xx/xx/xxxx  
Proposed  
C231

### SCHEDULE 16 TO CLAUSE 43.02 DESIGN AND DEVELOPMENT OVERLAY

#### QUEENS PARADE

**Map 5 - Precinct 5**

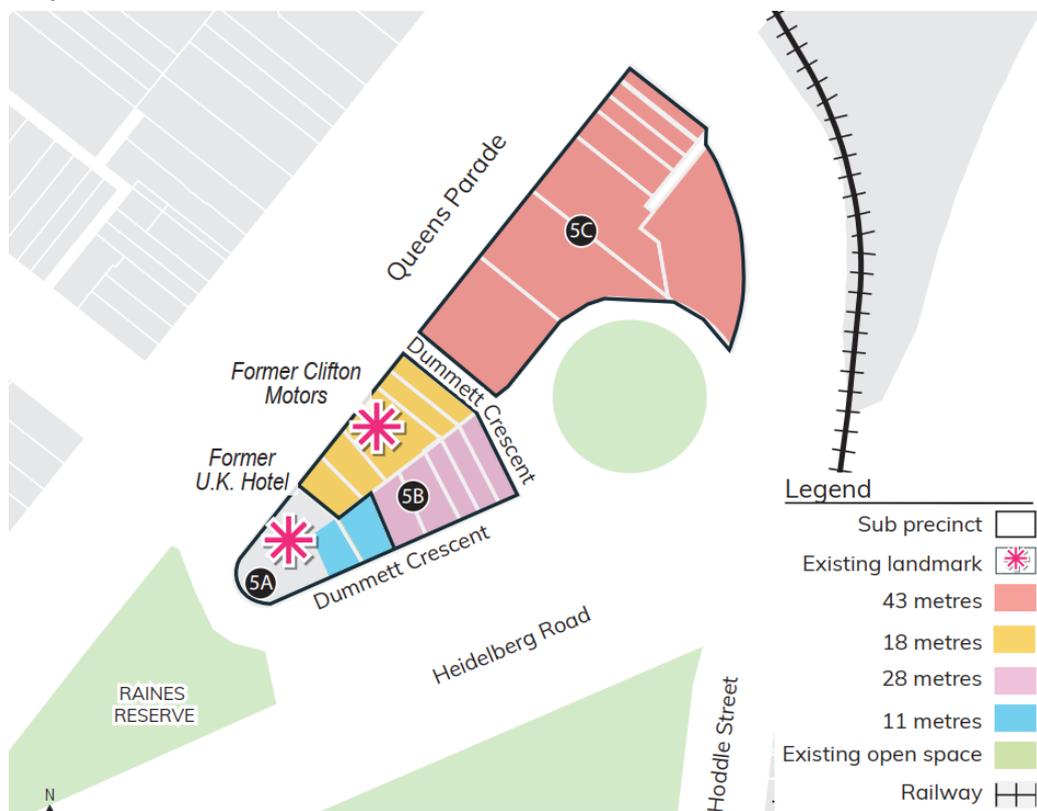
Include the viewpoints

- ~~retain~~ Retain the visual prominence ~~and not visually dominate the three dimensional forms~~ of the former United Kingdom Hotel when viewed from the key

[viewpoints as indicated on Map 5.](#) Raines Reserve and the former Clifton Motors Garage when viewed from the opposite side of Queens Parade.
